# Chesapeake modifications to Regional Standards Third Edition

DESIGN AND CONSTRUCTION STANDARDS	
	<b>FIRE HYDRANT SETTING (TYPE I)</b>	
08/15/03	REV. FOR INTERNET 2003	DR. BY: DATE:
DATE	REVISIONS	CHK. BY: DATE:
		APP. BY: DATE:

**WD\_06**

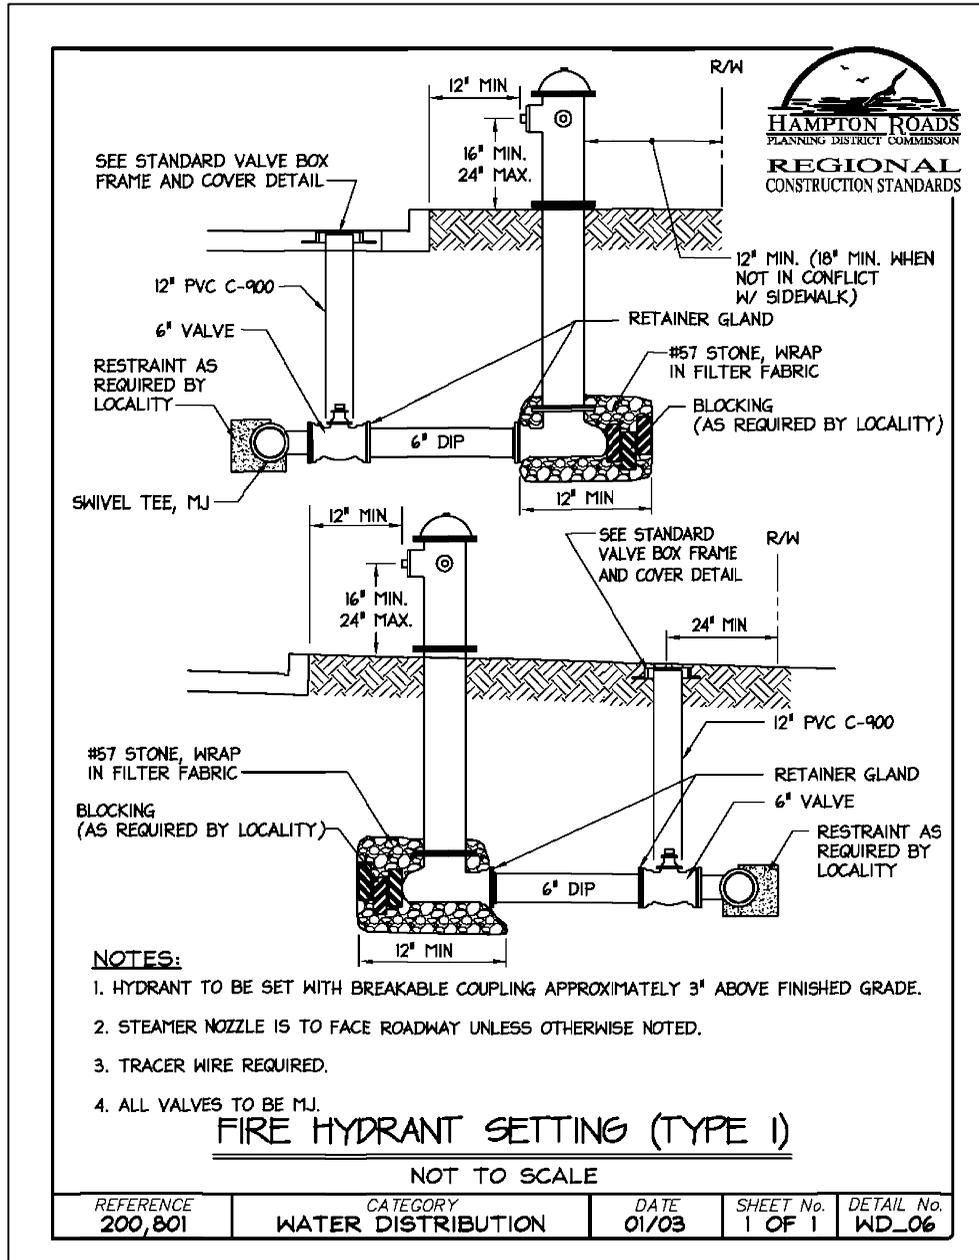
1. No thrust block to be installed on the tee for the hydrant.
2. Valves to be MJ X MJ and located 3 feet from the water main.
3. Minimum distance behind curb to be 18 inches.
4. Maximum distance as allowed by Fire Department.
